**ZONING AMENDMENT,
PLANNED UNIT DEVELOPMENT &
SUBDIVISION STAFF REPORT**

Date: August 7, 2014

Scientist Subdivision

1151 Dauphin Street
(Southwest corner of Dauphin Street and Oakland Terrace)

SITE PLAN

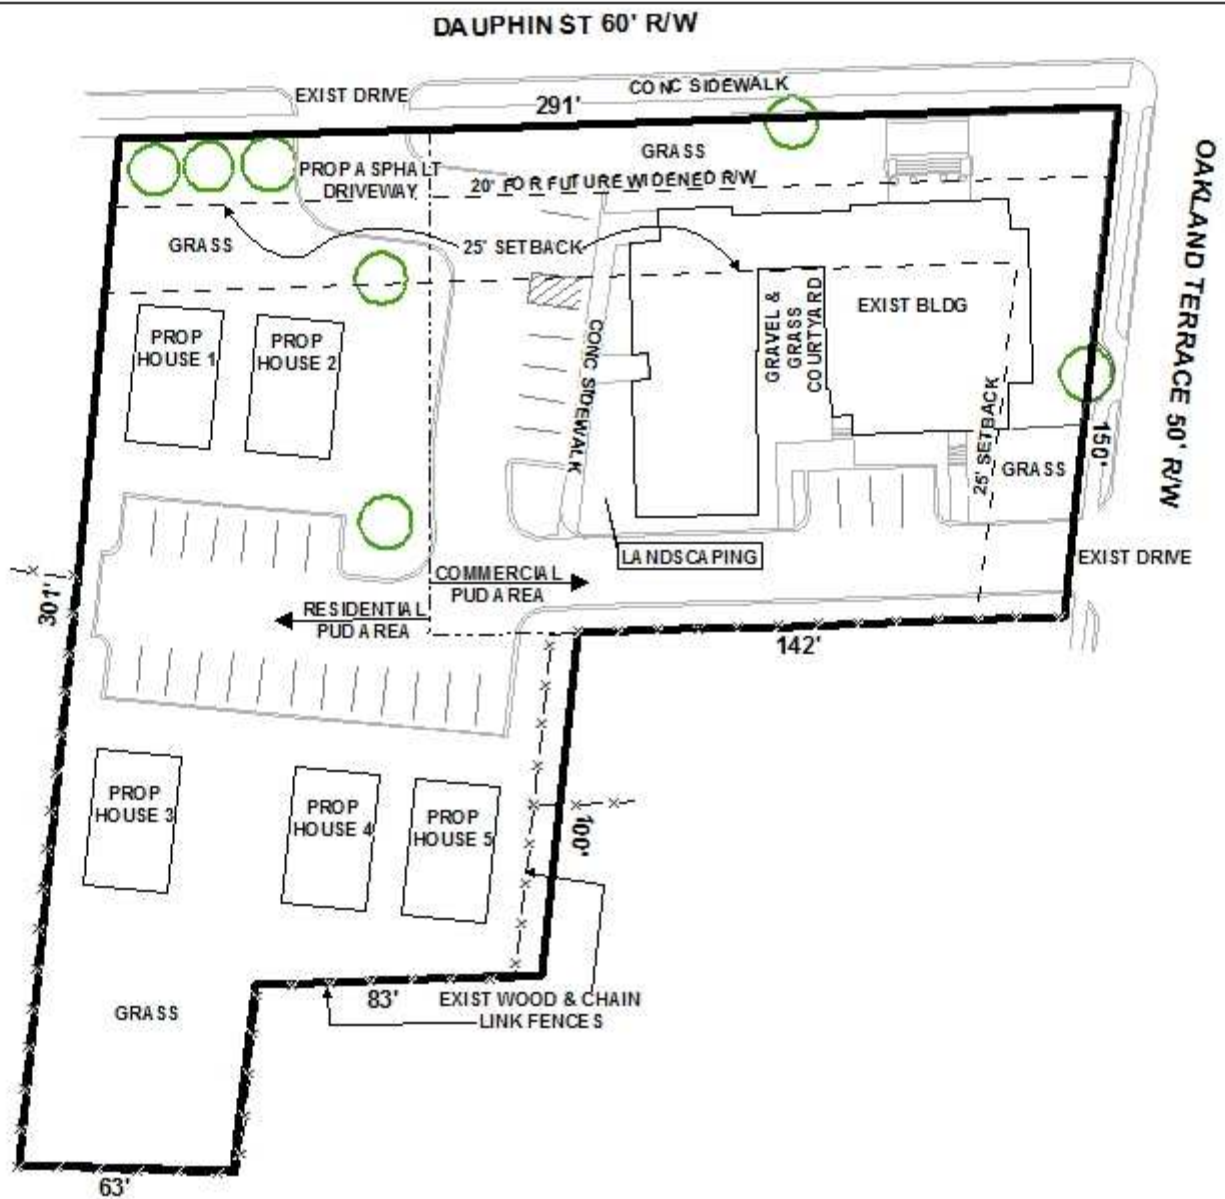
The applicant proposes to re-use the existing church buildings as general offices with no proposed expansion, and construct five single-family dwellings on the Western portion of the site. The existing curb cuts to Dauphin Street and Oakland Terrace are proposed to remain, but new asphalt paving and parking areas will be provided. Compliant parking stalls are proposed throughout; however, access and maneuvering areas vary from a 20'-width along the South of the existing buildings, to 22' along the West side of the buildings. As Traffic Engineering has indicated that 20' is the minimum acceptable width, such can be allowed via the PUD. The new parking area to the West is proposed to have a compliant 24'-wide access and maneuvering area.

With regard to the proposed mixed-use of the site, the existing 7,200 square-foot church building will remain, to be used as offices, and five 1,400 square-foot-minimum, 1-1/2-story single-family dwellings are proposed. As all structures are to be on the one lot, adequate green space must be provided. The site plan indicates that the residential portion of the site comprises 32,500 square feet. With 700 square feet of common area per dwelling unit required, a total of 3,500 square feet of common area are required, and 21,000 square feet are indicated to be provided. For the commercial portion, no landscaping calculations are provided, but if the total site consists of 1.4 acres (60,984 square feet), and the residential portion consists of 32,500 square feet, the commercial portion would then consist of 28,484 square feet. Of that, 12%, or 3,418 square feet of total landscaping would be required, and of that, 60%, or 2,051 square feet of frontage landscaping would be required. Staff calculations indicate landscaping compliance for the commercial portion also, but the site plan should be revised to also provide full landscaping calculations for the commercial portion. Landscaping calculations should be based upon the entire site as a whole and not broken down into residential use or commercial use.

The existing 42" and 54" Live Oak trees within the Western portion of the site are proposed to remain and, as per the Urban Forestry comments, are to be given Preservation status. The 36" Live Oak along Dauphin Street and the 54" Live Oak along Oakland Avenue are also proposed to remain. No tree planting plan is provided; however, if approved, the site plan should be revised to indicate a tree planting plan. As there is existing residential zoning adjacent to the South of the site, a 6' high wooden privacy fence would be required wherever the site is adjacent to residential zoning.

There is no indication of a dumpster on the site plan, nor is there any note stating alternative refuse collection provisions. Therefore, the site plan should be revised to indicate a compliant dumpster and pad, or a note should be furnished on the site plan stating that refuse collection will be either by curb-side pickup or private collection services.

Finally, the site will have 32 parking spaces. Parking areas with more than 10 spaces and that are used at night must be illuminated. Any existing and any new lighting must comply with the Zoning Ordinance requirements, including the provision that "lighting facilities used to illuminate signs, parking areas, or for other purposes shall be so arranged that the source of light does not shine directly into adjacent residence properties or into traffic." As the site will have more than 25 parking spaces, the applicant must submit information regarding new parking area lighting fixtures (including photometrics), indicate the locations on the site plan, and submit information regarding how any existing site lighting will be modified to comply with the requirements of Sections 64-4.A.2. and 64-6.A.3.c. and 64-6.A.8. of the Zoning Ordinance.

- 1) revision of the site plan to indicate a future right-of-way line 50' from the centerline of Dauphin Street;
- 2) revision of the site plan to illustrate the 25' minimum building setback line as measured from the future right-of-way line of Dauphin Street;
- 3) revision of the site plan to illustrate the 25' minimum building setback line along Oakland Terrace as measured from the existing right-of-way line;
- 4) revision of the site plan to provide landscaping ratios for both the residential portion and the commercial portion of the site;
- 5) revision of the site plan to provide tree planting calculations and a tree planting schedule;
- 6) placement of a note on the site plan stating that Preservation status is to be provided for the 42" and 54" Live Oak trees on the Western portion of the site and any work on or

- under these trees is to be permitted and coordinated with Urban Forestry; removal to be permitted only in the case of disease or impending danger;
- 7) revision of the site plan to provide a tree planting plan;

- 8) revision of the site plan to provide a 6' high wooden privacy fence wherever the site is adjacent to residential zoning;
 - 9) revision of the site plan to indicate a compliant dumpster and pad, or the placement of a note on the site plan stating that refuse collection will be either by curb-side pickup or private collection services;

- 10) submittal of a lighting plan for the site regarding new parking area lighting fixtures (including photometrics), indicating the locations, and submittal of information regarding how any existing site lighting will be modified to comply with the requirements of Sections 64-4.A.2. and 64-6.A.3.c. and 64-6.A.8. of the Zoning Ordinance;
